City of Sugar Hill
Planning Staff Report
CBD Design Review 18-01552

DATE: November 2, 2018
TO: Mayor and Council, Design Review Board
FROM: Planning Director KA
SUBJECT: Central Business District (CBD) design review
1091 Level Creek Road
Proposed multi-family development, 360 Residential LLC.

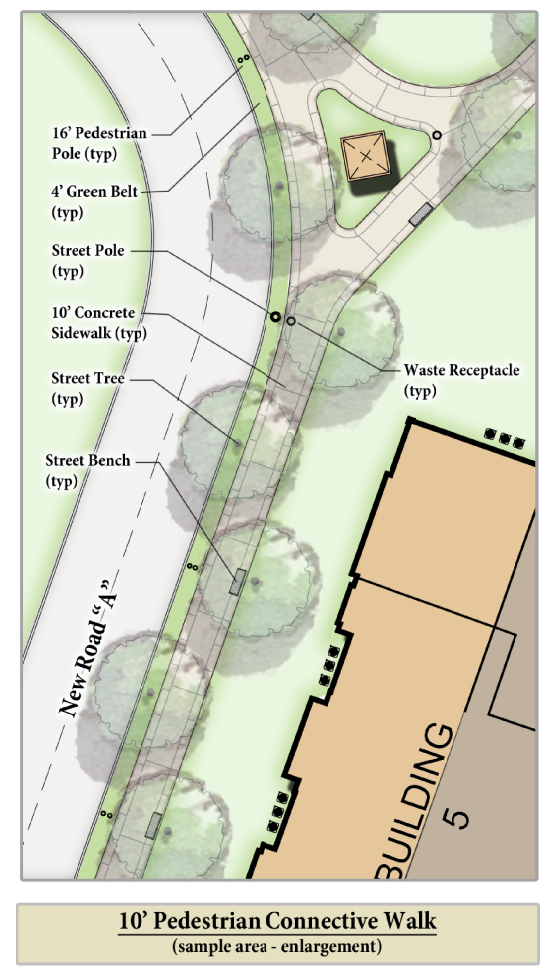
3. As shown on exhibit C1, the areas along New Road A in front of buildings 3, 4 and 5 shall be incorporated into the streetscape as garden or plaza space (does not have to be programmed for use, can be visual only). Turf grass shall be discouraged between the sidewalk and buildings and shall not exceed 15% coverage in the final landscape design.

- A slightly deeper setback along New Road A is agreeable if the design team uses the additional space to integrate the building into the streetscape. i.e. plaza space, gardens, pocket parks, etc.... Wide areas of turf grass between the sidewalk and building are not appropriate.
